### KNOXVILLE HISTORIC ZONING COMMISSION STAFF REPORT - CERTIFICATE OF APPROPRIATENESS APPLICATION

PROPERTY ADDRESS: 1437 Grainger Ave 37917 FILE NO.: 6-M-18-HZ

**DISTRICT: Old North Knoxville H-1**

**MEETING DATE:** 6/21/2018

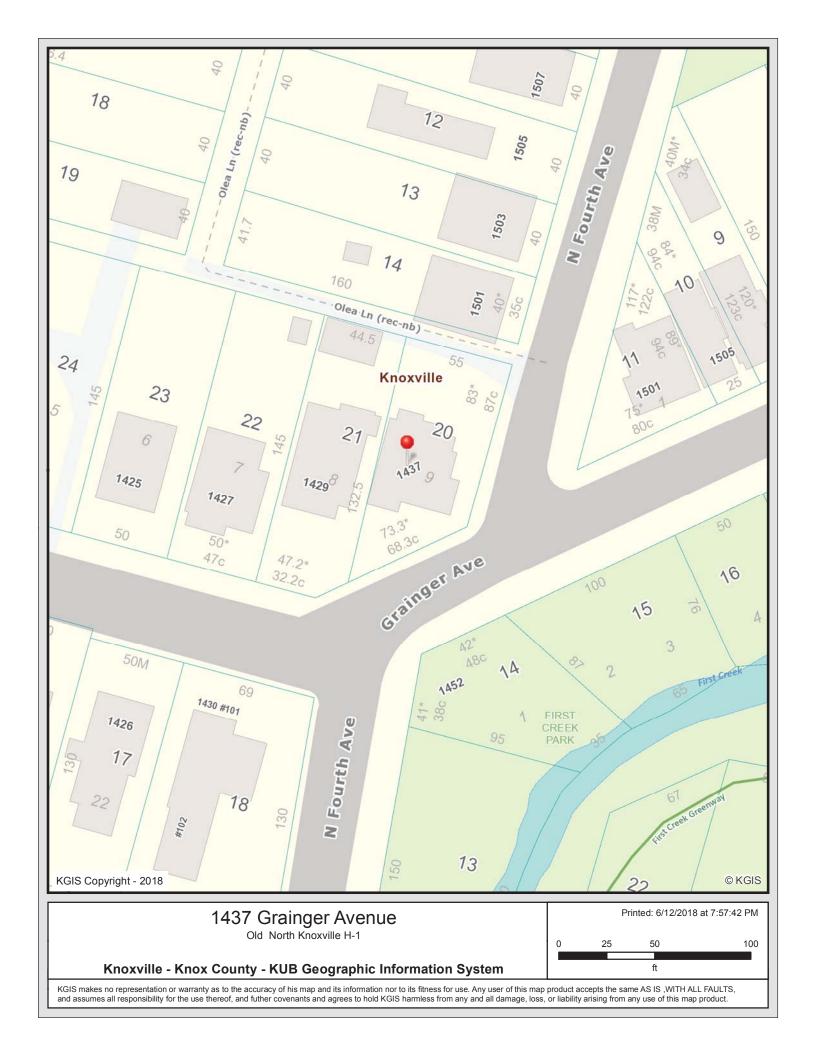
- 9) The Queen Ann cottages in the districts typically have an engaged (half post) and a full post flanking the steps. The post to the left of the steps should be an engaged or half-post. A fourth porch post should be added to the right of the steps and a middle post should be centered in the remaining space. The step handrails should be attached to the porch posts flanking the steps in order to the porch design to be more typical for this style of house.

Staff recommends approval with the condition that a fourth porch post be added to the right of the steps and that the middle post be centered in the remaining space. The step handrails are to be attached to the porch posts flanking the steps. The post to the left of the steps is to be an engaged or half-post. The rear deck is approved contingent on the size being provided.
